SNL SAR Review: Thermal

FCMA – Taipei Taiwan

February 6th 2007

Carlos Lopez
Materials Transportation Testing and Analysis
Department
Sandia National Laboratories*

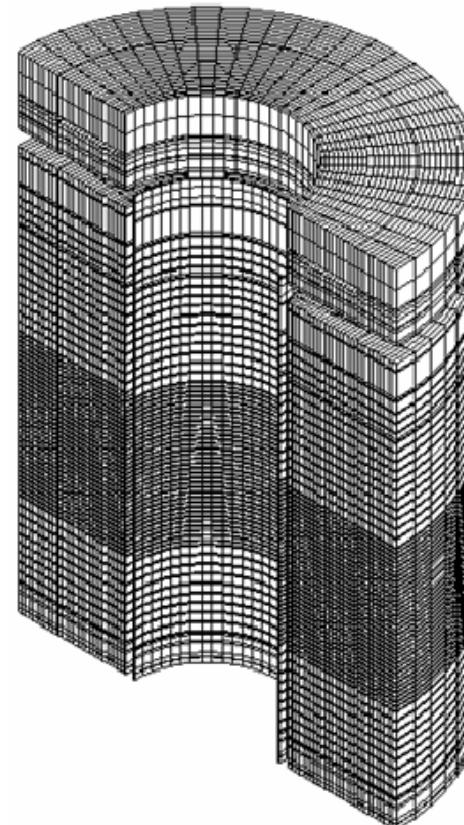
- **ANSYS FEA models (p. 6.3.5-20)**
 - The mesh is denser closer to the base of the canister and concrete cask. However, no explanation is provided for this peculiarity.

- Table 6.3.7-4 Maximum Temperatures of the Cladding and Major Components for the Normal Storage Condition

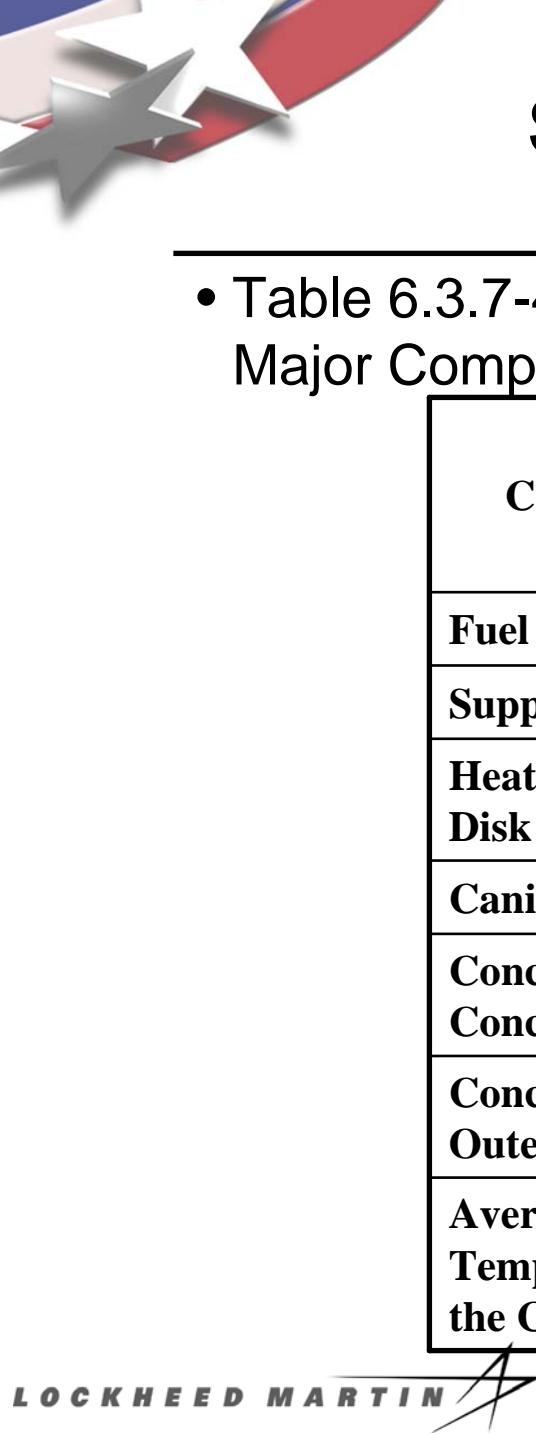
Temperatures
are very close
to the limit

- **Table 6.3.7-4 (p. 6.3.7-39)**
 - The bulk temperature of the concrete cask and the added concrete shield are very close to the temperature limit. However, the temperature limit seems low. This may not be a problem, especially if the license application is for 7 kW heat removal capacity (14 kW heat load was assumed for the analysis of the Normal Storage Condition). This comment also applies to item 3 on page 6.3.8-1 and Table 6.3.8-1 on page 6.3.8-3.
